DETROIT DIESEL

ATS Technician's Guide

NUMBER: 07 ATS-3 **S.M. REF.:** Listed in Table 1 **ENGINE:** ATS **DATE:** December 2007

SUBJECT: ADDITIONAL PROCEDURES WERE ADDED TO AFTERTREATMENT SYSTEM

Figure 1 Vertical Aftertreatment Device Wiring Diagram

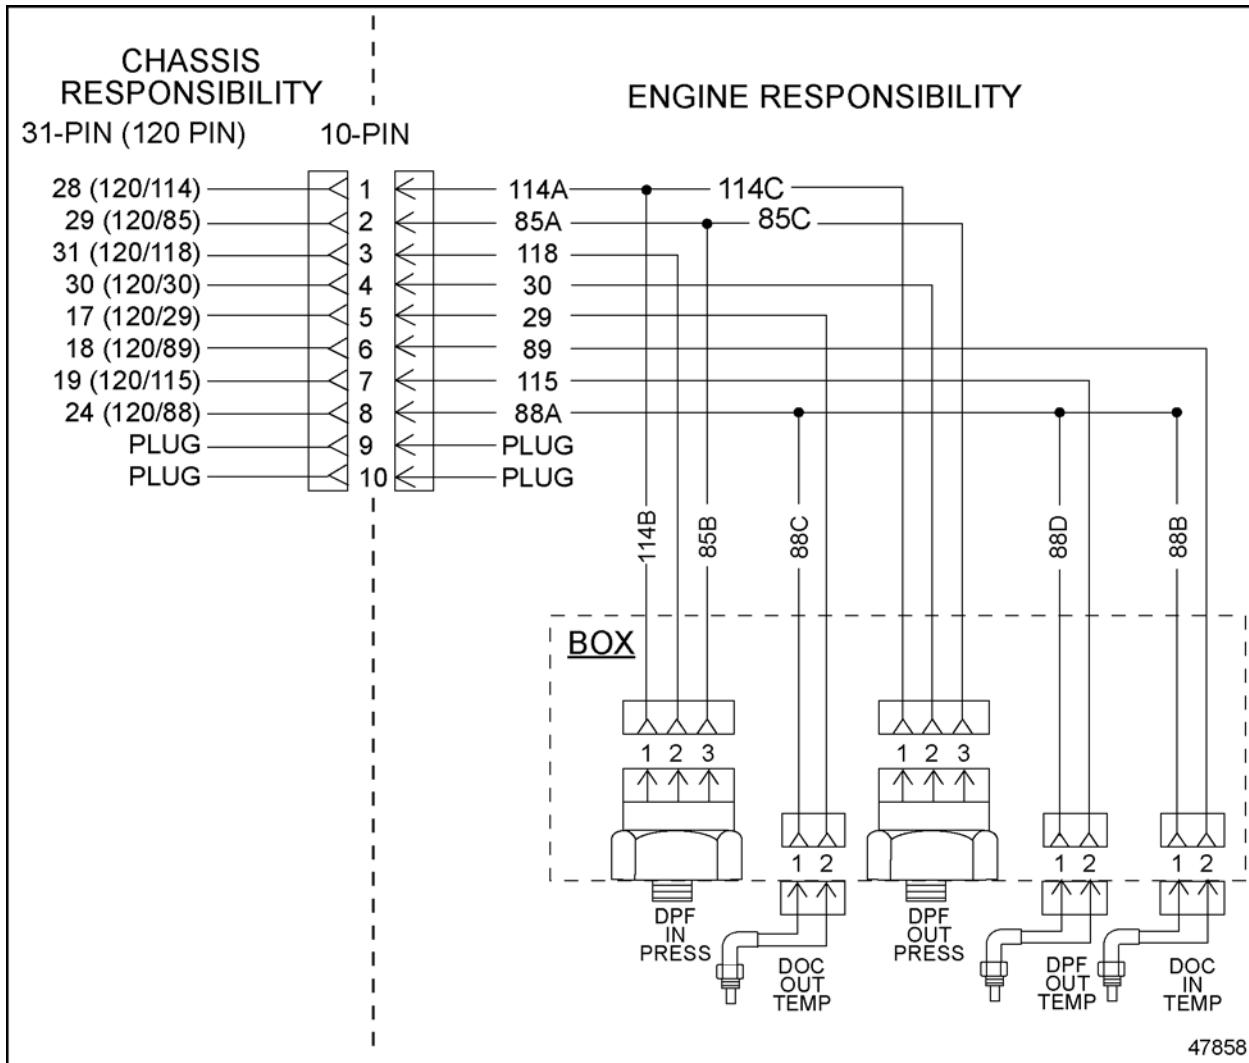
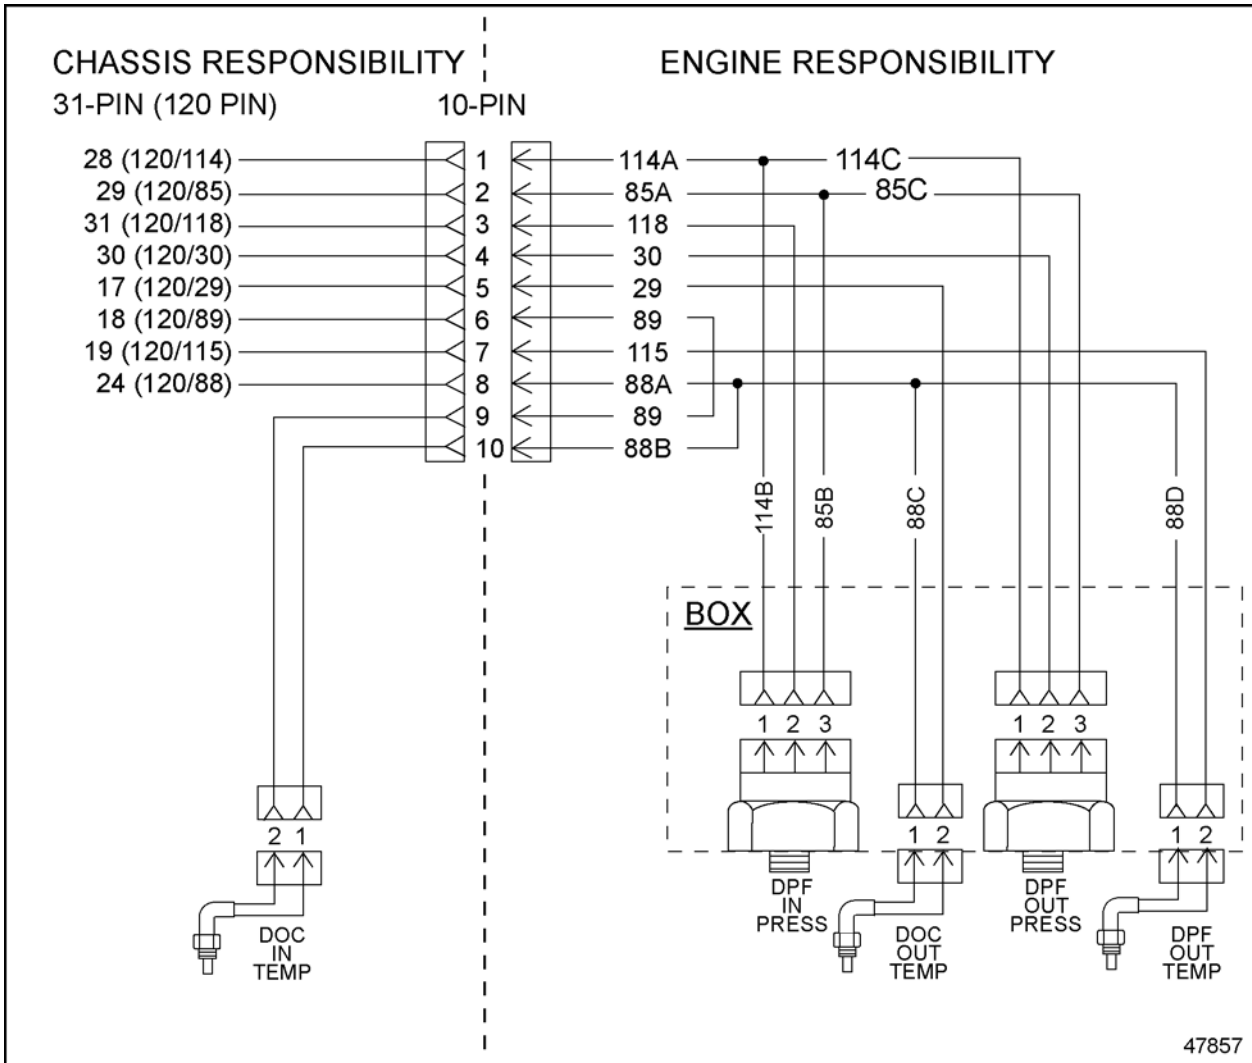
SPN 3242/FMI 8

This diagnostic condition indicates the MCM has detected an impossible temperature shift on the DOC Inlet Temperature Sensor. The most likely cause is an intermittent wiring problem. See Figure 1 and Figure 2 for the ATD wiring schematics.

CHECK FOR DIESEL OXIDATION CATALYST INLET TEMPERATURE SENSOR TEMPERATURE WIRING PROBLEM

1. Connect DDDL 7.0 or later version.
2. Turn ignition ON (key ON, engine OFF).
3. Check for multiple codes.
 - [a] If fault 3242/3 or 3242/4 is active, troubleshoot this fault first. Verify repairs.
 - [b] If fault 3242/3 or 3242/4 and fault 3242/8 are inactive, go to step 4.

4. Start engine.
5. Access the Voltage Service Routine.
6. Select “Start Acquiring”.
7. Wiggle test the harness while looking for abnormal voltage spikes on T_DOC_IN (pin 89).
 - [a] If a voltage spike is detected, isolate that section of harness and inspect for wiring chaffing, corrosion, improper connections, or physical damage. Repair damage as necessary. Verify repairs.
 - [b] If no voltage spikes are seen, physically check and clean all harness connectors between the DOC Inlet Temperature Sensor and the MCM. Repair damage as necessary. Verify repairs.

Figure 3 Vertical Aftertreatment Device Wiring Diagram

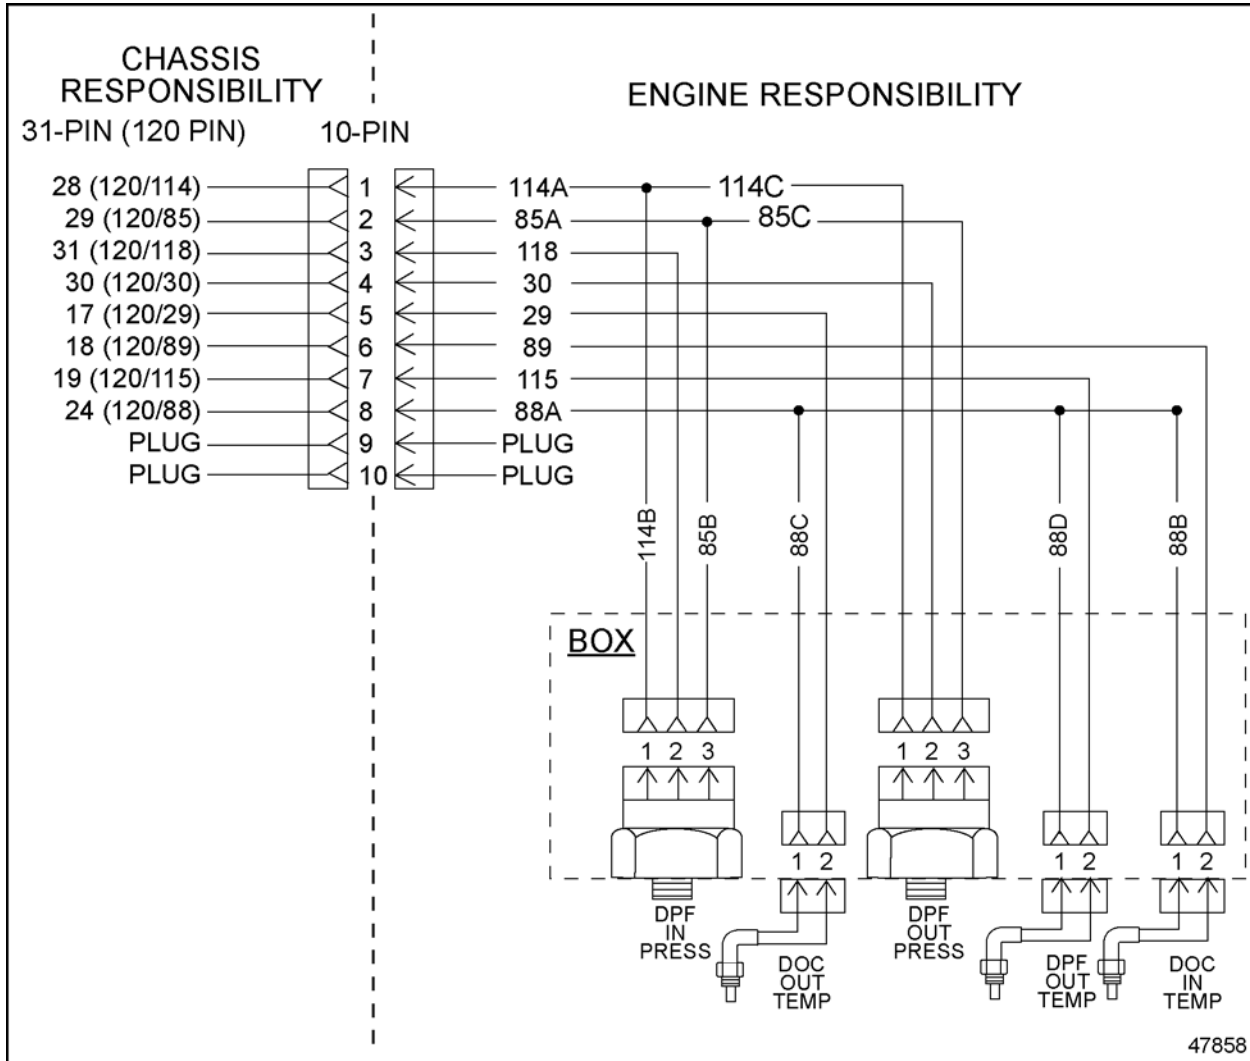
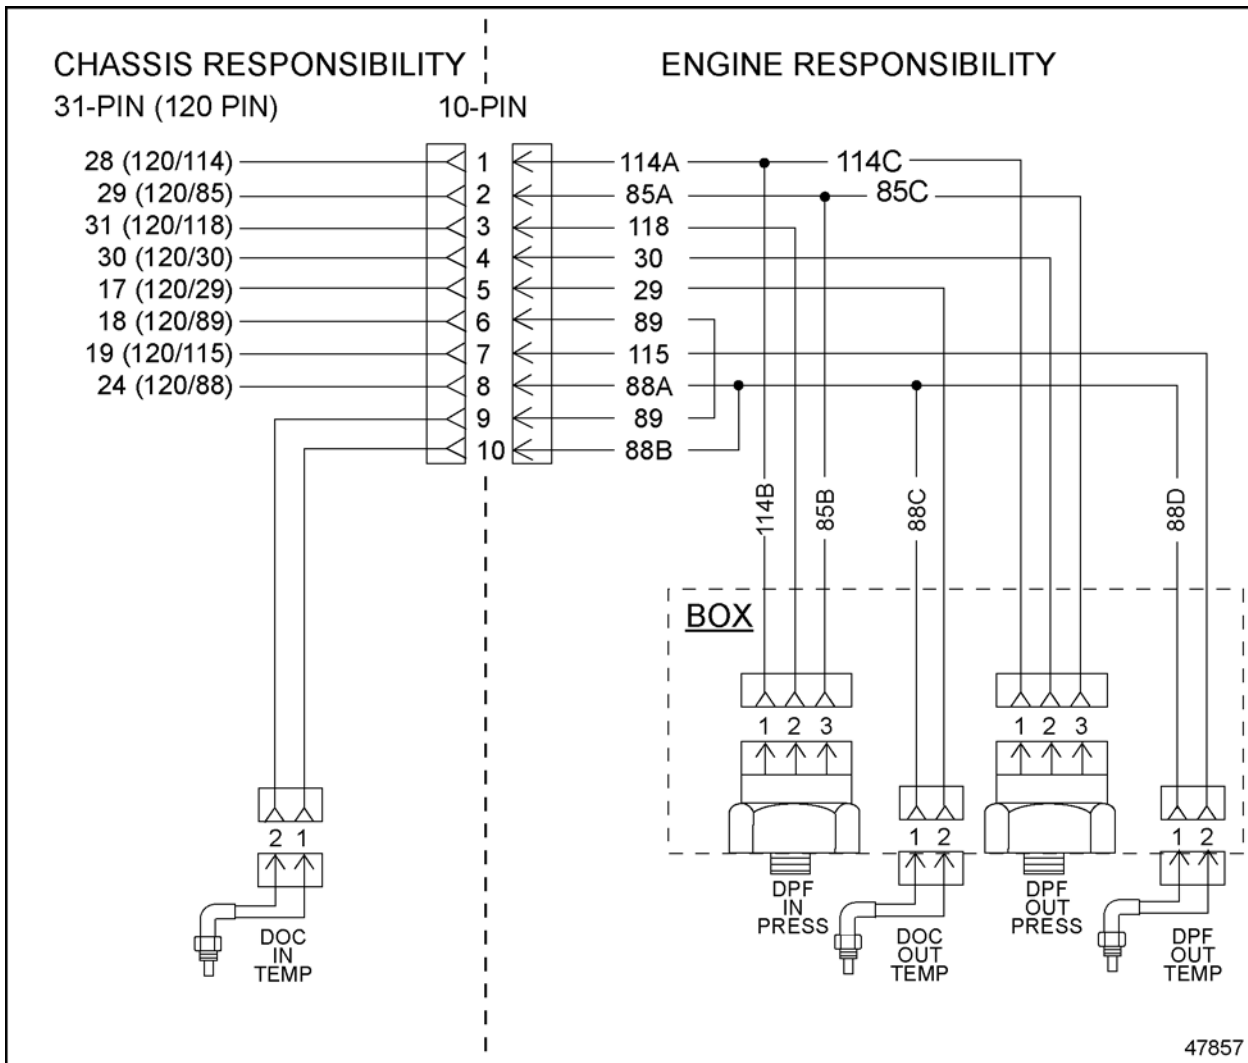
SPN 3250/FMI 8

This diagnostic condition indicates the MCM has detected an impossible temperature shift on the DOC Outlet Temperature Sensor. The most likely cause is an intermittent wiring problem. See Figure 3 and Figure 4 for the ATD wiring schematics.

CHECK FOR DIESEL OXIDATION CATALYST OUTLET TEMPERATURE SENSOR TEMPERATURE WIRING PROBLEM

1. Connect DDDL 7.0 or later version.
2. Turn ignition ON (key ON, engine OFF).
3. Check for multiple codes.
 - [a] If fault 3250/3 or 3250/4 is active, troubleshoot this fault first. Verify repairs.
 - [b] If fault 3250/3 or 3250/4 and fault 3250/8 are inactive, go to step 4.

4. Start engine.
5. Access the Voltage Service Routine.
6. Select “Start Acquiring”.
7. Wiggle test the harness while looking for abnormal voltage spikes on T_DOC_OUT (pin 29).
 - [a] If a voltage spike is detected, isolate that section of harness and inspect for wiring chaffing, corrosion, improper connections, or physical damage. Repair damage as necessary. Verify repairs.
 - [b] If no voltage spikes are seen, physically check and clean all harness connectors between the DOC Outlet Temperature Sensor and the MCM. Repair damage as necessary. Verify repairs.

Figure 5 Vertical Aftertreatment Device Wiring Diagram

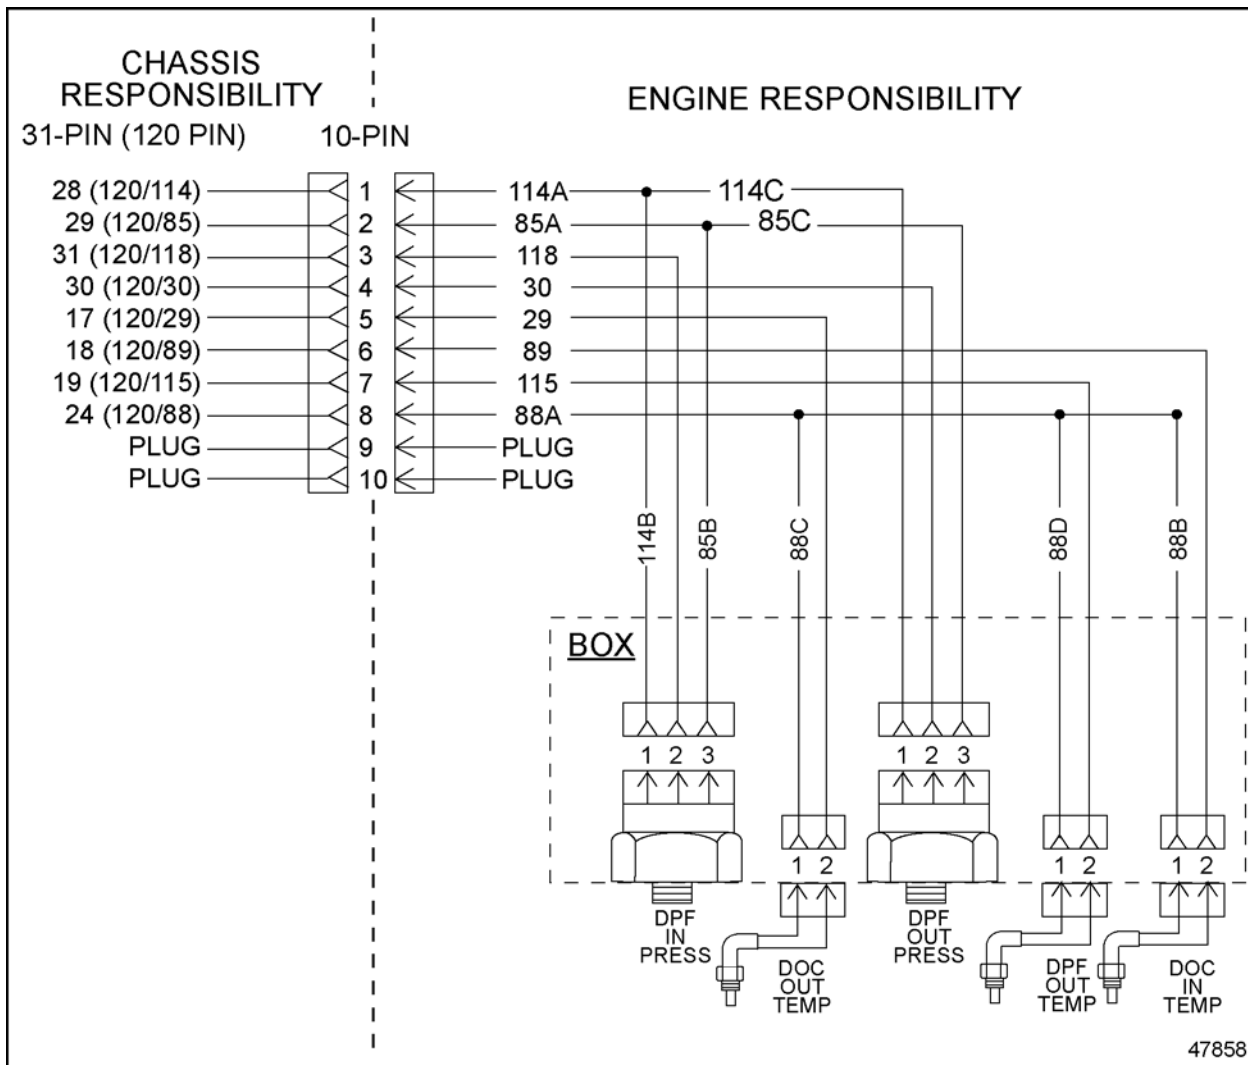
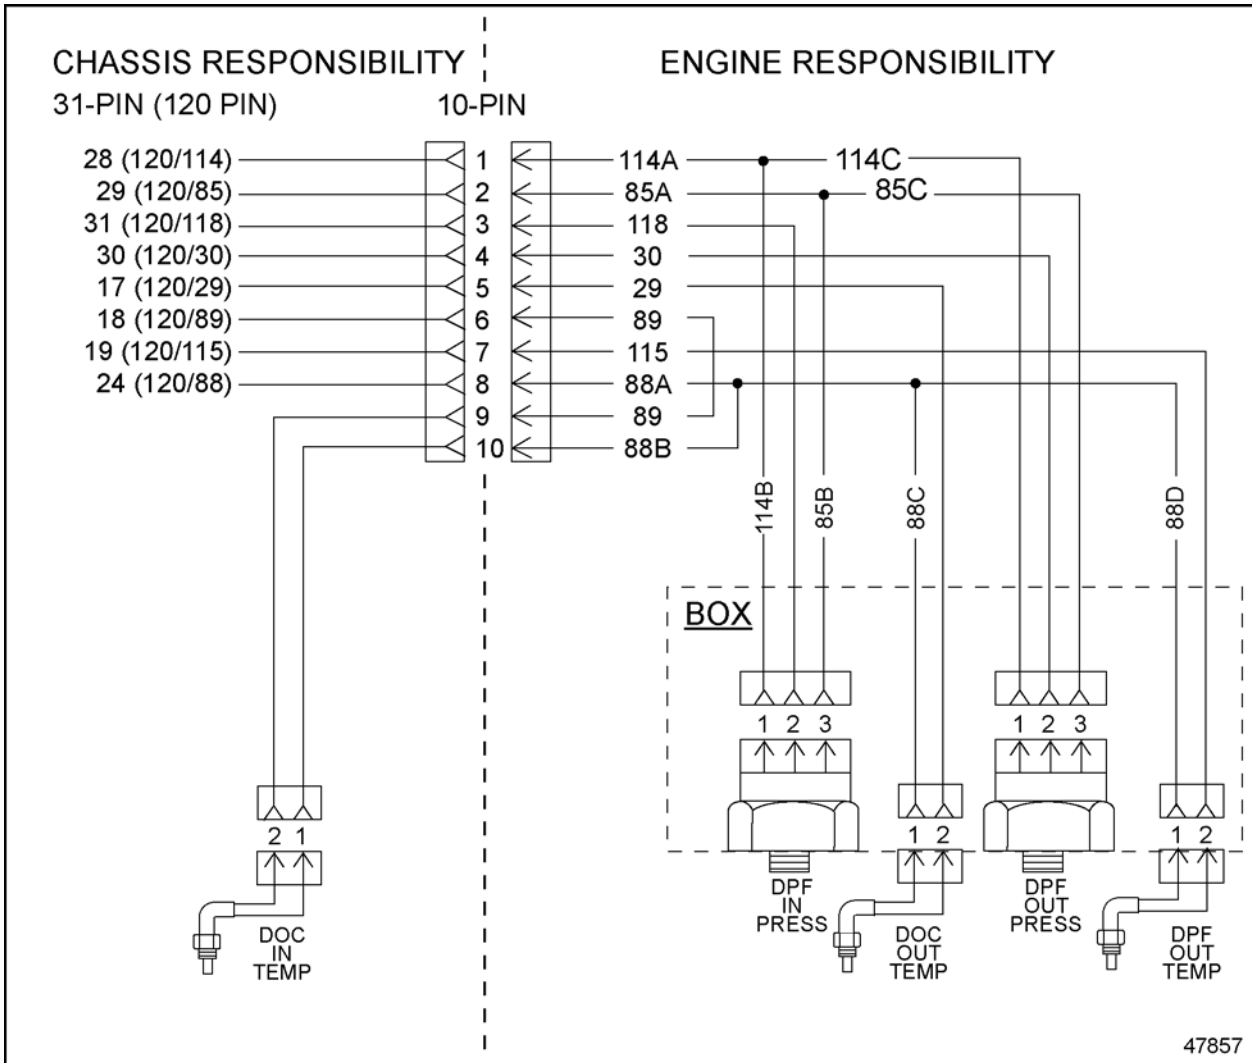
SPN 3609/FMI 8

This diagnostic condition indicates the MCM has detected an impossible temperature shift on the DPF Outlet Temperature Sensor. The most likely cause is an intermittent wiring problem. See Figure 5 and Figure 6 for the ATD wiring schematics.

CHECK FOR DIESEL PARTICULATE FILTER OUTLET TEMPERATURE SENSOR TEMPERATURE WIRING PROBLEM

1. Connect DDDL 7.0 or later version.
2. Turn ignition ON (key ON, engine OFF).
3. Check for multiple codes.
 - [a] If fault 3609/3 or 3609/4 is active, troubleshoot this fault first. Verify repairs.
 - [b] If fault 3609/3 or 3609/4 and fault 3609/8 are inactive, go to step 4.

4. Start engine.
5. Access the Voltage Service Routine.
6. Select “Start Acquiring”.
7. Wiggle test the harness while looking for abnormal voltage spikes on T_DPF_OUT (pin 115).
 - [a] If a voltage spike is detected, isolate that section of harness and inspect for wiring chaffing, corrosion, improper connections, or physical damage. Repair damage as necessary. Verify repairs.
 - [b] If no voltage spikes are seen, physically check and clean all harness connectors between the DPF Outlet Temperature Sensor and the MCM. Repair damage as necessary. Verify repairs.
